Product Information

PI671

Subject V Range New Wireless & Door Controller

ECM: 718469

Transmitter – 8 button Wireless #7056408

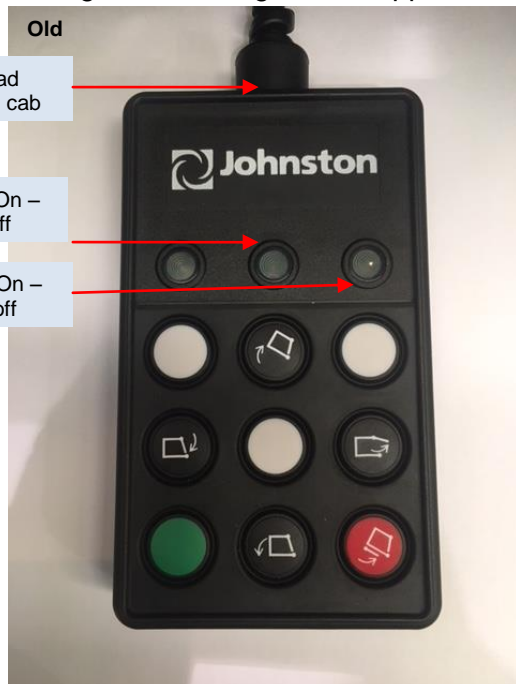
We are pleased to offer a wireless radio controller as standard.

This provides the operator with greater flexibility and range when both operating the rear door and raising and lowering of the hopper. It also eliminates the risk of damage to the pendant cable.

There is an on/off switch to the rear and a green LED will illuminate to confirm power. A belt clip is also provided as standard.

Please note that the LED's (Amber LED On – Handbrake off, and Green LED On – Handbrake on) are no longer available. Functionality remains unchanged and operation is not possible should the handbrake not be engaged.
